TENNESSEE VALLEY AUTHORITY

SUBJECT: WATTS BAR NUCLEAR PLANT UNIT 1 - PROGRAM FOR NRC-OIE BULLETIN 79-14 PHASE 2 INSPECTIONS

SUBJECT: PHASE II 79-14 INSPECTION PACKAGES.

79-14 PHASE II INSPECTION FORMS

SHT. 109

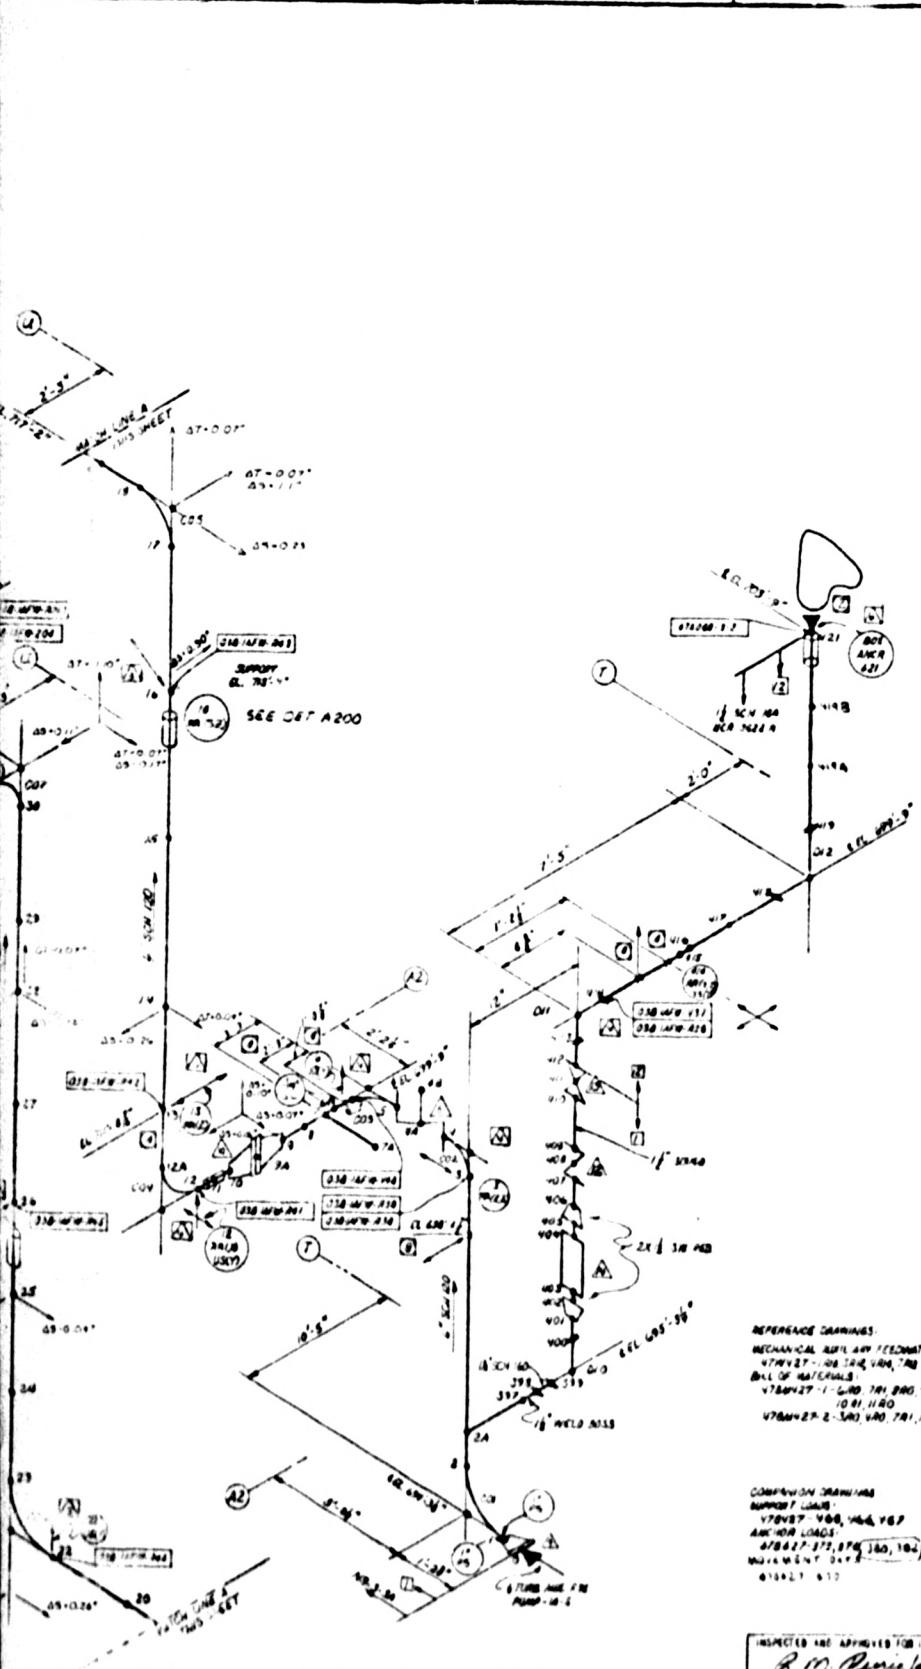
| DISCREPANCY NO. | DEVIATION NO. | DISCREPANCY DESCRIPTION | RESOLUTION |
|-----------------------------|---------------|---|------------|
| IT68- 47W465- 206/09C | 38C | POTENTIAL INTERFERENCE W/ CONDUIT. | CEB |
